# TECHNICAL SERVICE BULLETIN

Technical Service Bulletin: 400-1459

The charge controller for the solar panel charger may be wired incorrectly.

# TECHNICAL SERVICE BULLETIN 400-1459 REMEDY INSTRUCTIONS

FIGURE 1

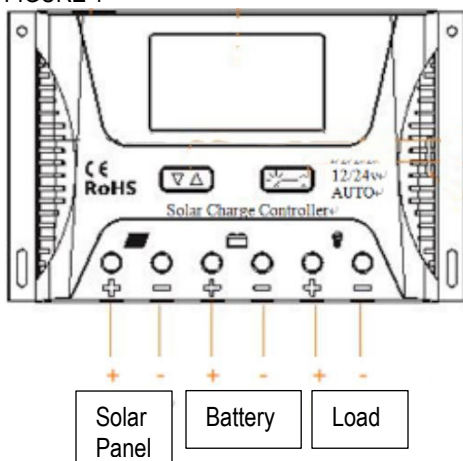
- SEE FIGURE 1 FOR THE LAYOUT OF THE SOLAR CHARGE CONTROLLER, FOR REFERENCE;
- IF THE WIRING IN THE UNIT IS THE SAME AS FIGURE 2, MOVE ON TO THE REMEDY STEPS;
- IF THE SOLAR CHARGER IS THE SAME AS FIGURE 3, THE SOLAR CHARGER IS WIRED CORRECTLY AND DOES NOT NEED THE REMEDY, CLAIM ONLY THE INSPECTION;
